Access Compliance Report Public Rights-of-Way (Curb Ramps)

Main Street: UNIVERSITY_DR Cross Street: IRVINE_AVE Location: N

ADA ID: RPRK211018115242 Ramp Type: Type 1 - Perpendicular Diagonal Initial Pass/Fail: Pass Overall Compliance: No Severity Score: 2

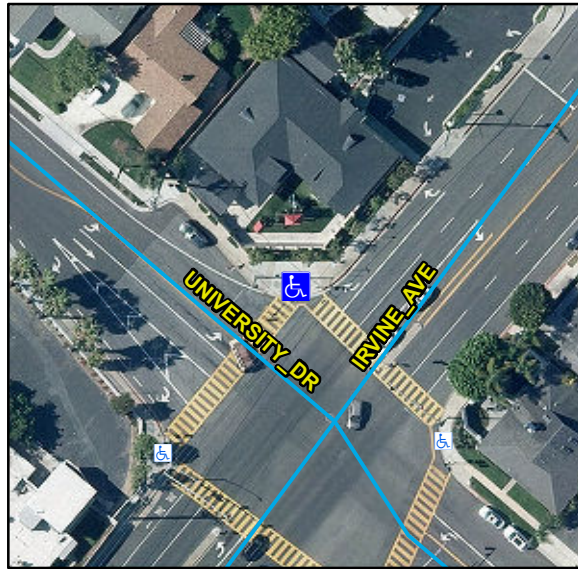
Remove & Replace Curb Slope.

Yes	Ramp Inside Crosswalk 1	Yes	Yes	Ramp Inside Crosswalk 2	Yes
	Crossing 1 Slope (%)	2.3		Crossing 2 Slope (%)	2.5
	Crossing 1 Cross Slope (%)	4.5		Crossing 2 Cross Slope (%)	1.6
Yes	Gutter Ponding	No	No	Curb Slope	5.5
Yes	Gutter Lip Height (in)	0		Road Run Slope (%)	0.9
Yes	Gutter Run Slope (%)	3.8		Road Cross Slope (%)	2
Yes	Gutter Cross Slope (%)	1.9			
Yes	Overall Surface Condition: Acceptable		Yes	Perp Joint Present	Yes
	Cross Gutter Present?	No		Spandrel Present?	No
	Replace Cross Gutter?	N/A		Replace Spandrel?	N/A

R304.2.2, STD 1115
